**A G E N D A**  
**JAMES CITY COUNTY DEVELOPMENT REVIEW COMMITTEE**  
**REGULAR MEETING**  
**Building A Large Conference Room**  
**101 Mounts Bay Road, Williamsburg, VA 23185**  
**October 26, 2016**  
**4:00 PM**

**CONCEPTUAL PLAN-0031-2016. 4501 Noland Blvd., AutoZone**

**CONCEPTUAL PLAN-0031-2016. 4501 Noland Blvd., AutoZone**  
**Staff Report for the October 26, 2016, Development Review Committee**

**CONCEPTUAL PLAN-0051-2016. Forest Glen Section 5**

**MASTER PLAN FOR REZONING**  
**LIGHTFOOT MIXED USE DEVELOPMENT**

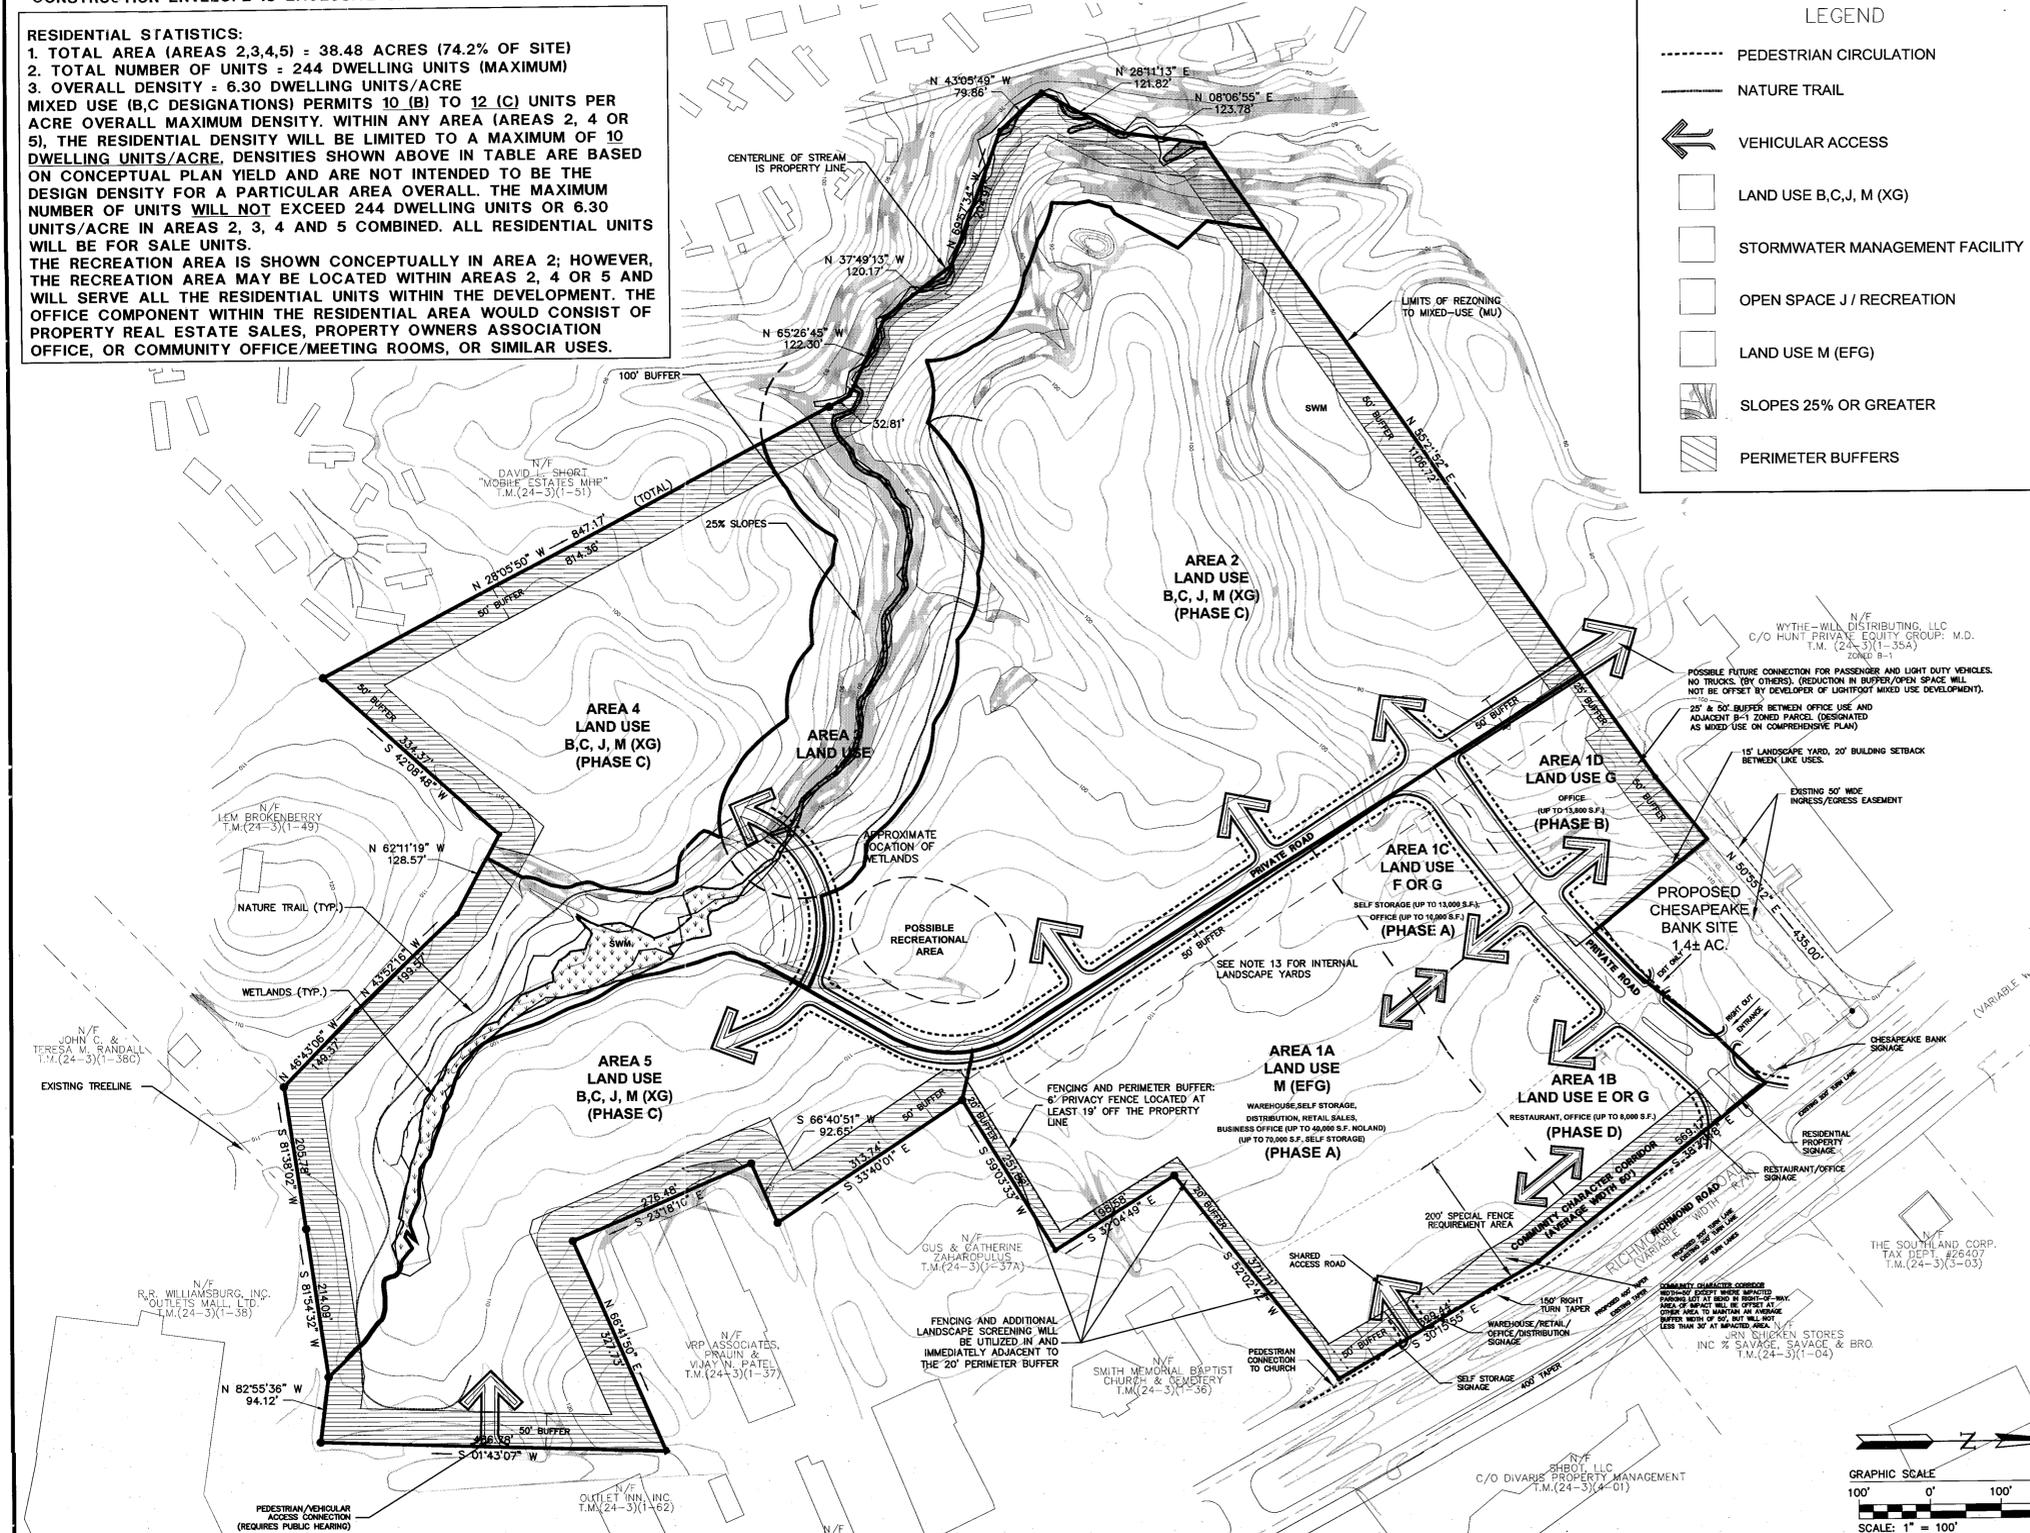
1. The proposal differs from the use in Master Plan Area 1B, as compared with the adopted master plan and with what the DRC had previously found consistent with the master plan.

Staff recommends that the DRC affirm the Planning Director’s conclusion that the proposal significantly alters the character of land uses and as such, is not consistent with the legislatively adopted master plan.

Color Elevation  
 AutoZone Store #6194  
 Williamsburg, Virginia

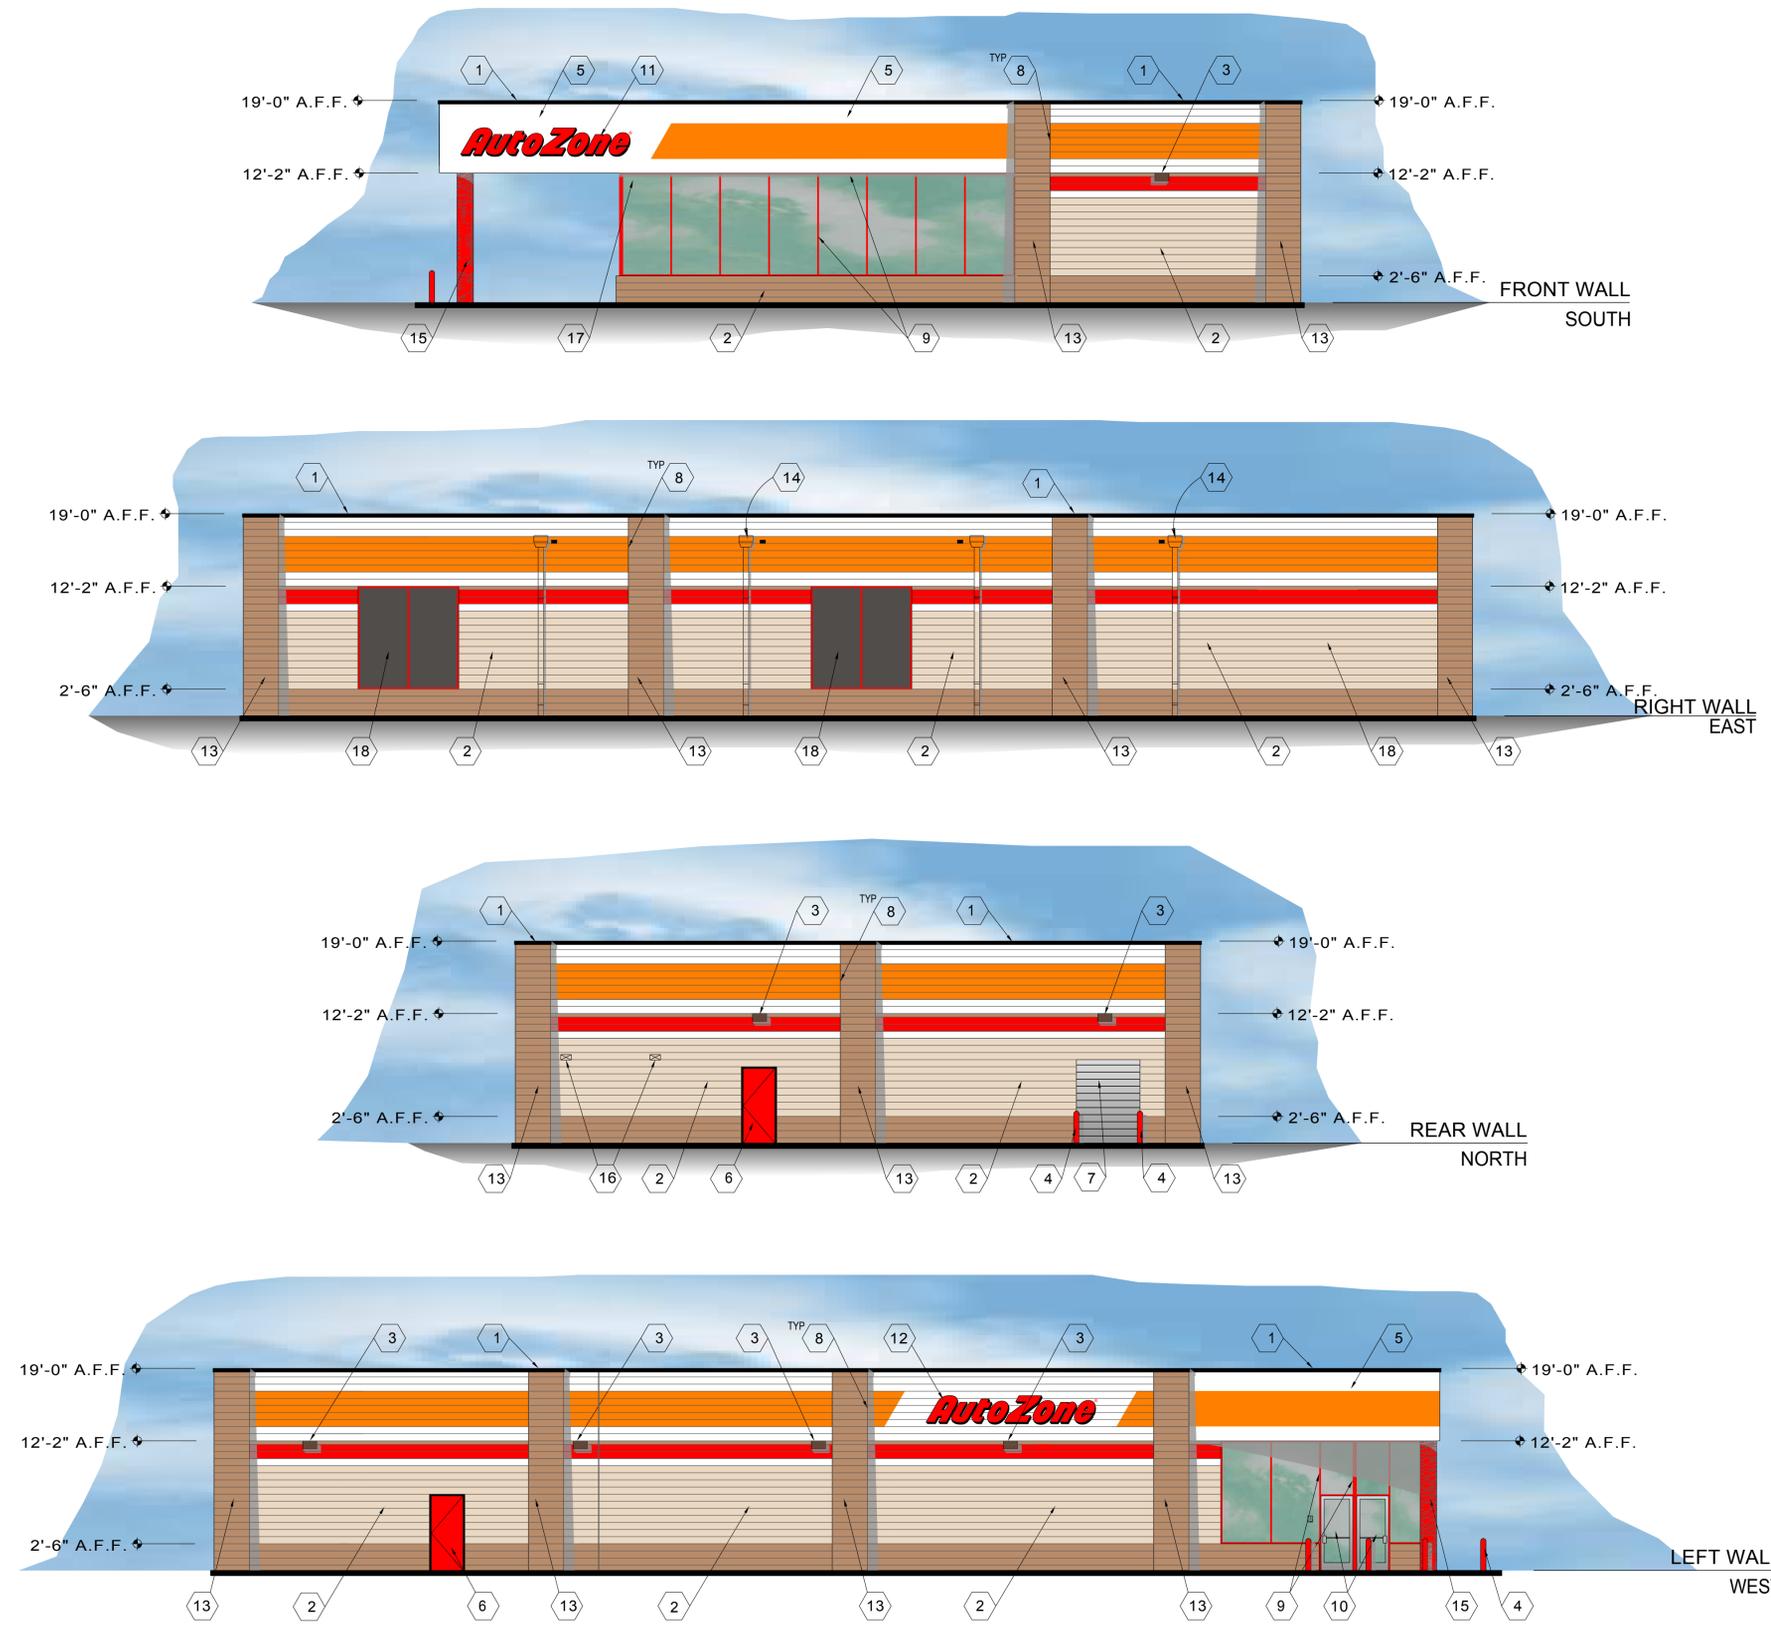
The second set of items provided by the applicant is an updated building elevation and a landscaping plan to show how the building will be screened. Staff had previously noted that there were no elevations or design guidelines submitted or proffered as part of the Lightfoot Mixed Use rezoning. The only criteria for the appearance of the building are found in Proffer 11, which states that “the building walls of all buildings facing Route 60 shall be constructed of brick, glass, masonry or better split faced block, dryvit, stone, manufactured stone, or siding as determined by the Director of Planning. All rooftop mechanical equipment will be screened from view from Route 60.” The applicant had provided an elevation for the DRC’s consideration at the meeting on September 28 (see

Should the DRC choose not to affirm the Planning Director’s conclusion and find the proposal consistent, staff recommends the DRC consider including conditions such as a commitment to follow-through on the site plan amendment, use of the proposed building elevation (Attachment No. 5), and use of the proposed landscape plan (Attachment No. 6).

Color Elevation  
 AutoZone Store #6194  
 WILLIAMSBURG, VIRGINIA

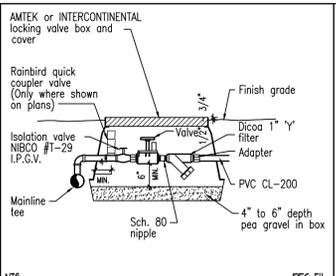
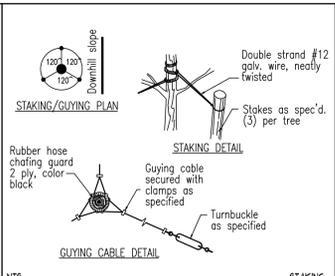
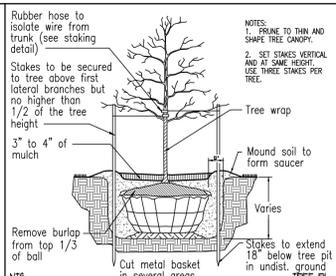
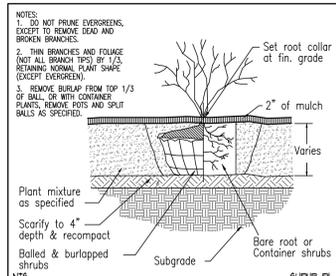
Attachment No. 4) and the new proposed elevation is included as Attachment No. 5. The applicant provided information that the following changes were made in the new elevation: use of softer earth-tones, addition of faux windows, addition of vertical pilasters and the use of split-face block in place of plain concrete masonry units (CMU). The landscaping plan showing proposed screening of the building is included as Attachment No. 6.
